July 31, 2020

Re: NHTSA Notice of Proposed Rulemaking to Amend FMVSS No. 108 to Permit Adaptive Driving Beams, NHTSA Docket No. 2018-0090, 83 Fed. Reg. 51766 (October 12, 2018)

Figure 4. Low-Beam Headlamp Intensity Pattern from NHTSA Feasibility Study

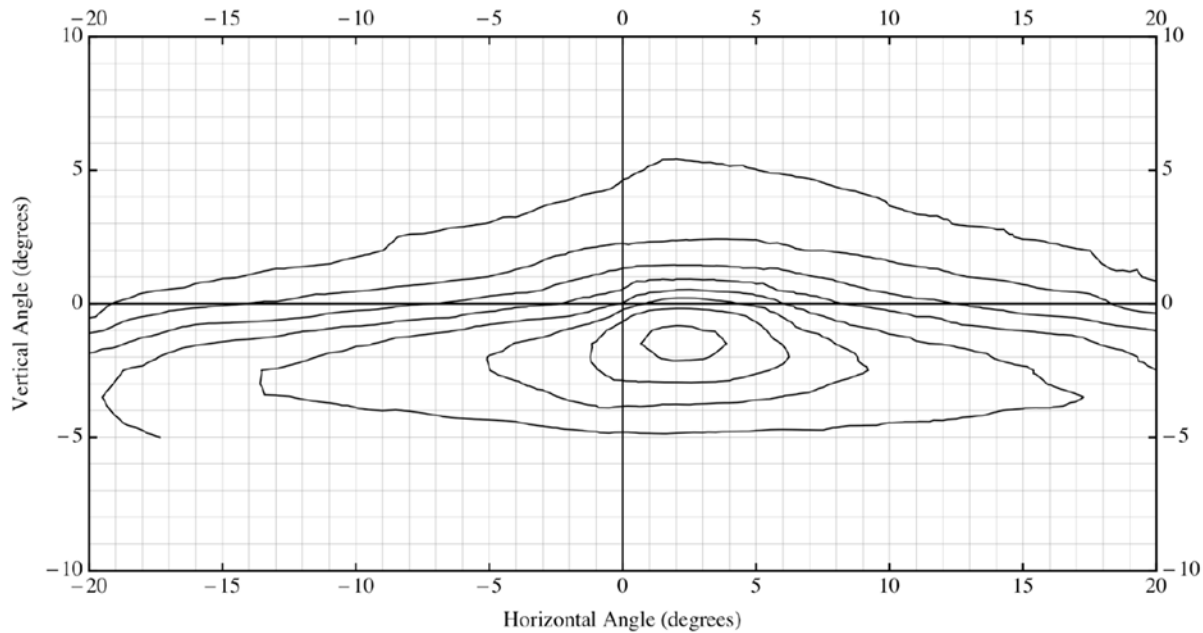
NHTSA proposes a set of glare limits from a 2011 University of Michigan Research Institute (“UMTRI”) Feasibility Study (“Feasibility Study”), which is derived from reported median photometry of headlamps from 1997 model year U.S. vehicles.¹² Since 1997, headlight technologies that comply with FMVSS 108 have advanced drastically, including in the form of LED or high-intensity discharge (“HID”) lighting that can provide greater levels of visibility without producing excessive glare. In addition to advancements in lighting hardware, in 2016 the IIHS introduced its Headlight Rating (“IIHS Headlight Rating”) which has incentivized U.S. automakers to provide high levels of visibility without sacrificing glare performance.¹³

Third, the IIHS study accounts for glare effects due to incidence angle whereas the Feasibility Study does not. This is the basis for allowing 10 lux of glare illuminance for all approaches at distances between 5 and 10 meters, noting that “[a]t these smaller distances, drivers are less likely to be focused on the oncoming vehicle headlamps, and greater angular distances from the light sources are associated with less discomfort glare (Schmidt-Clausen and Bindels 1974).” Our test data shows that the least amount of failures occurred at the 15-29.9 meter distance range for both the oncoming and preceding scenarios. Additionally, the glare exceedance times for all the test failures in this range were 1.0 seconds or less. Based on these results, we believe that it is less critical to test the performance of ADB systems at this distance range. Accordingly, Auto Innovators recommends that NHTSA eliminate the 15-29.9 meter distance requirement for each oncoming and preceding test scenario.

Figure 5. Low-Beam Headlight Intensity Pattern from IIHS Headlight Rating

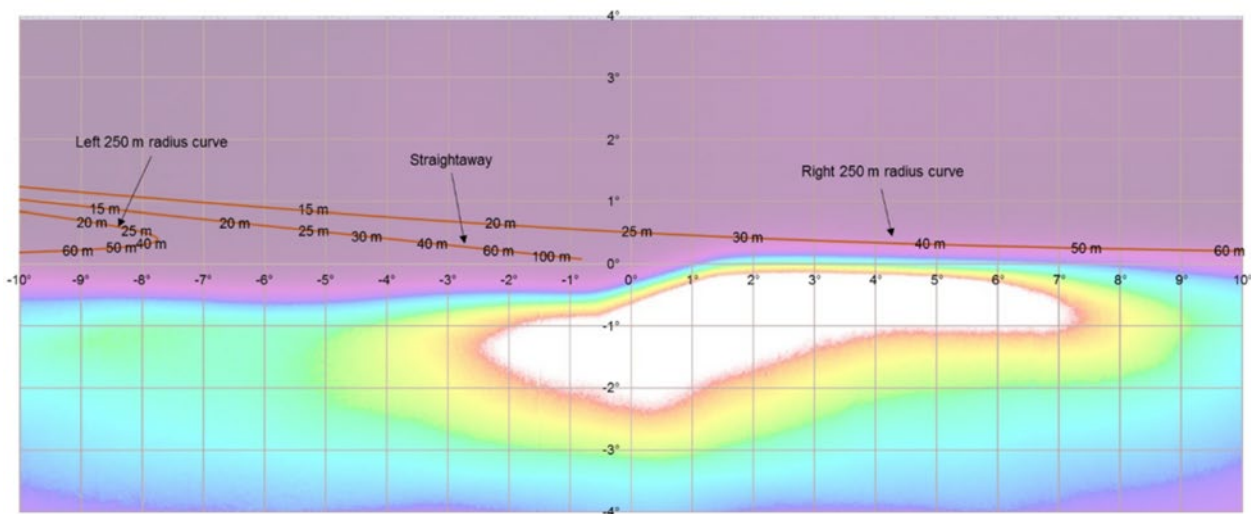
As indicated in the rationale for the IIHS Headlight Rating, the IIHS takes a similar approach to the 2011 UMTRI Feasibility Study for establishing illuminance requirements.¹⁴ In both studies, the illuminance of U.S. vehicle lower beam headlamp patterns compliant to FMVSS 108 are measured and extrapolated to establish illuminance criteria at different distances. However, the IIHS study departs

from the Feasibility Study in three significant ways. First, the Feasibility Study uses “lamps typical of the 1997 model year”, whereas the IIHS study uses lamps that are representative of headlamps on U.S. roads today.¹⁵ Figures 4 and 5 below demonstrate the respective difference between the lower beam headlamp patterns used in the Feasibility Study and the IIHS study. Second, the IIHS study accounts for prior research that indicates that glare effects should consider both peak illuminance and overall “dosage” of glare exposure. This is the basis for the IIHS glare threshold that assesses illuminance in terms of overall exposure distance.

Figure 6. Glare illuminance versus distance of 32 IIHS GOOD rated MY2020 vehicles (blue) overlaid with NHTSA ADB NPRM glare limit values (red)

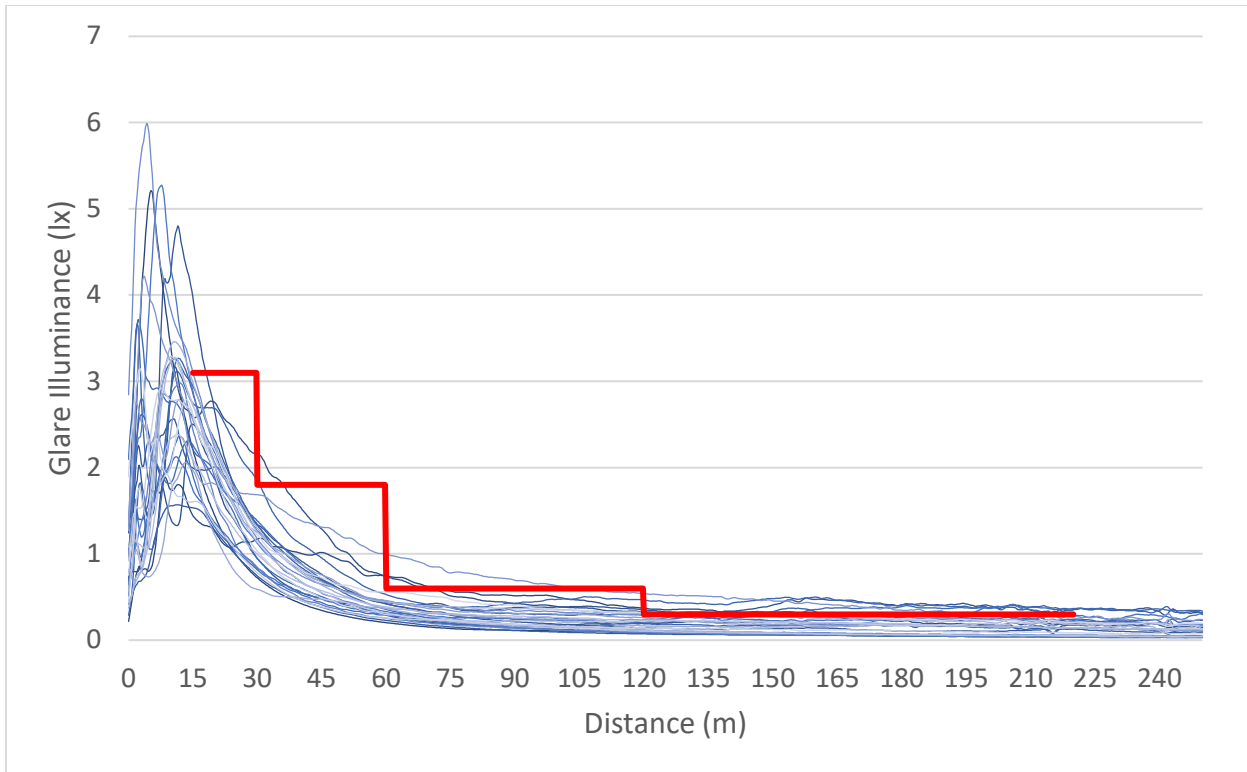
The IIHS Top Safety Pick criteria for headlamps has driven the industry to the current state of the art in increasing the need for visibility with simultaneous reductions in glare. IIHS “GOOD” rated headlamps serve to influence consumers’ purchasing decisions through these ratings. When comparing the glare results of the model year (“MY”) 2020 Top Safety Pick Plus (“TSP+”) award winners having GOOD rated headlamps to the glare limit values provided in the present NPRM, it is clear that the glare limit values for ADB lamps are unreasonably stringent. The graph below presents the glare illuminance values from each of the 32 GOOD rated headlamps, and subsequent TSP+ vehicles, which are overlaid with the glare illuminance limits cited in the NPRM.

As evidenced in Figure 6, nine of the 32 GOOD rated headlamps (~28%) in the *low beam* configuration would fail the oncoming glare limits provided for in the NPRM. Because the highest IIHS rated lower beam headlamps would struggle to even meet the glare criteria requirements to which ADB lighting is being held, Auto Innovators believes that a relaxation of the glare limit values is appropriate. To align with IIHS consumer messaging for what constitutes a “good” headlamp, we recommend also aligning closer to the glare limits specified in the IIHS Headlight Evaluation.

Auto Innovators believes that the glare limits presented in the IIHS test protocol, which examines visibility and glare from a real world perspective, reflect the performance bar set by modern headlights more accurately than the overly restrictive limits proposed in the NPRM. We recommend that the Agency adopts the glare limits utilized in the IIHS Headlight Evaluation as outlined below.

IIHS test, earn a POOR rating, and still be fully FMVSS 108 compliant. For these reasons, we believe adopting the higher glare metric of the IIHS right curve scenario to apply to all oncoming scenarios offers sufficient balance between the need for limiting glare exposure while allowing for the benefits of ADB. Although IIHS provides a gradient of glare exposure limits, we recommend that NHTSA's proposed stepwise glare illuminance limits correlate to the IIHS curve at each step's shortest distance. Specifically, Auto Innovators offers the following modified glare limit criteria for the Agency's consideration:

Distance (m)	Lux Limit (lx)
30 to 59.9	6
60 to 119.9	3.4
120 to 220	1
